ALAMEDA COUNTY
HEALTH CARE SERVICES

March 26, 2007

Subject: Fuel Leak Case No. RO0000278, Desert Petroleum, 2008 1ST Street, Livermore, CA

ACEH staff has reviewed the "Field Investigation for Source Zone Remediation" (field investigation), dated June 6, 2006, the "Soil Vapor Intrusion Risk Assessment" (risk assessment), dated May 31, 2006, the "Source Zone Remediation Plan" (remediation plan), dated August 11, 2006, the "Fourth Quarter 2006 Groundwater Monitoring Report," dated January 16, 2007, and previous monitoring reports, all prepared by Golder Associates (Golder).

Head Profile CMT-4

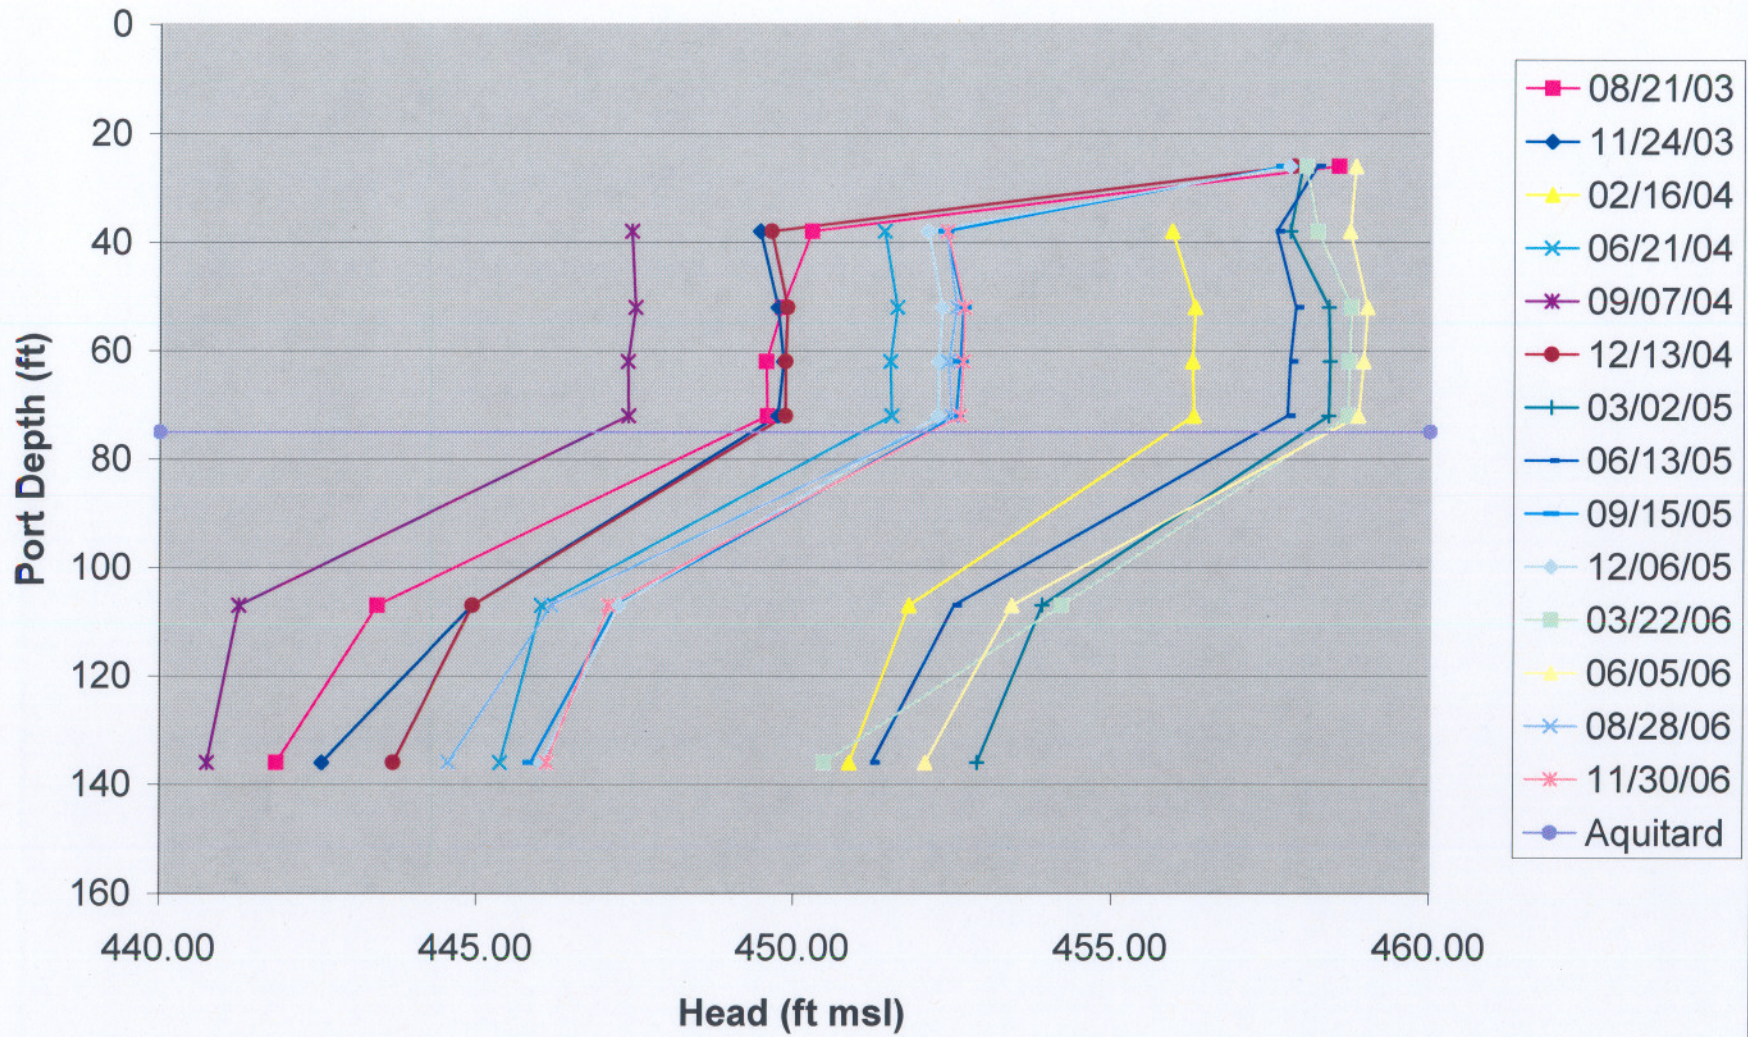
ACEH has prepared a Head Profile plot for CMT-4 (attached) for your reference. A review of this plot shows the same head levels in ports above 75-feet bgs which are completed in the shallow unconfined aquifer. Below 75-feet bgs an aquitard exists as evidenced by head levels much different than in the ports above the aquitard. Also, a very strong downward gradient below a depth of 75-feet is apparent.

Regarding Golder's hypotheses, the consistent head data above the aquitard and strong downward gradient below the aquitard from these plots immediately discount theory 4) cross contamination via the well bore for the CMT pipe, Golder has no data to substantiate this theory. For hypothesis 1) carry down of contamination as part of drilling; if this were the case it would be expected that these detections would likely have ceased several months after well installation due to the limited mass. Instead you are still detecting the contamination nearly 4-years after well installation. Regarding hypothesis 2) cross contamination resulting from diffusion of BTEX through CMT chamber walls; ACEH does not concur with this as diffusion through the walls would require a significant concentration gradient for diffusion to occur and your analytical data do not support this hypothesis. Hypothesis 3) cross contamination due to MW-1 penetration of the aquitard, does seem likely as MW-1 is cross connecting the aquifers, and both ACEH and Golder have recommended decommissioning this well. We request that your consultant continue to study this plot and evaluate other potential hypotheses and provide rationale to validate or discount each hypothesis. Include the results of this evaluation in SCM 2.0.

**PCE CONCENTRATIONS
SPLIT SAMPLING FROM TS#62**

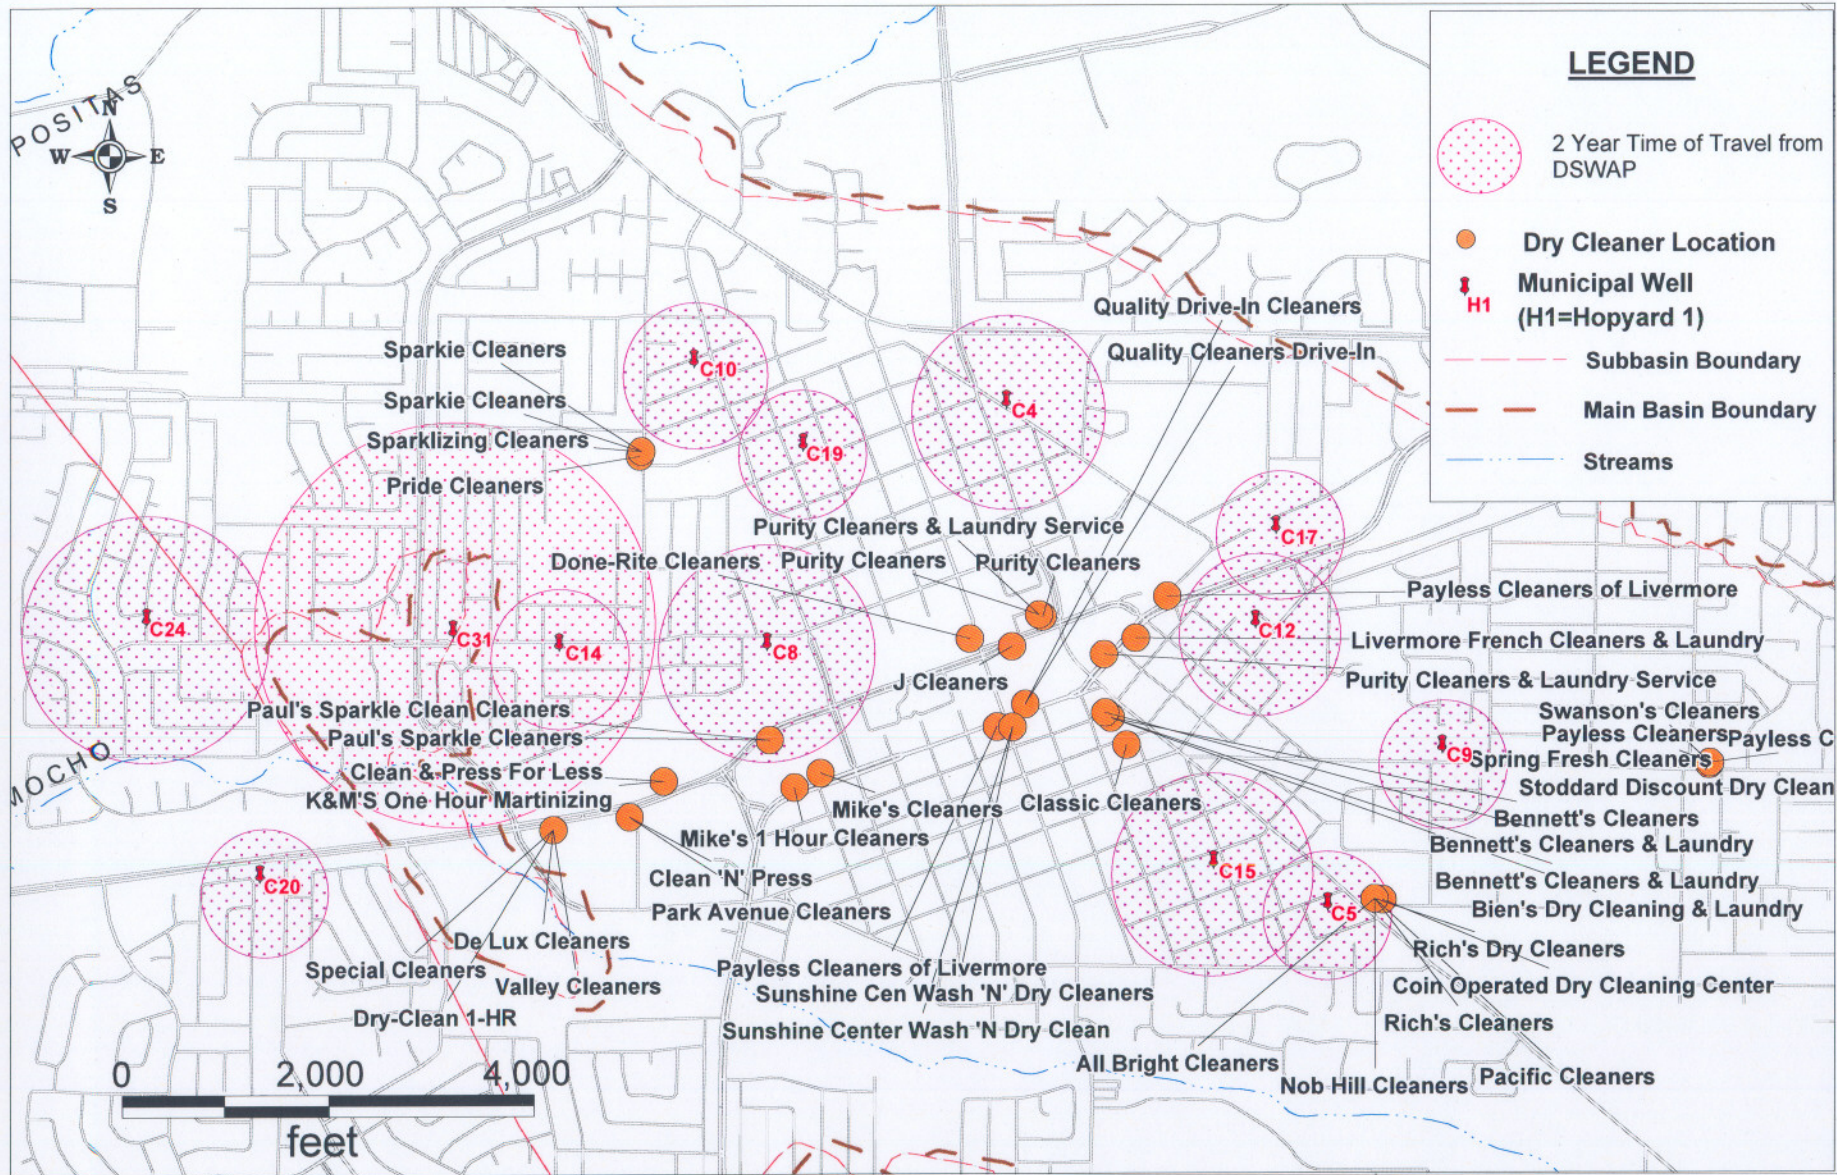
Additionally, PCE has been detected in your monitoring well network, including the CMT ports below the aquitard, (see attachment) in the split samples collected by Zone 7 Water Agency and in your MIP samples. Please also include a consideration of this data when evaluating hypotheses for contaminant transport in SCM 2.0.
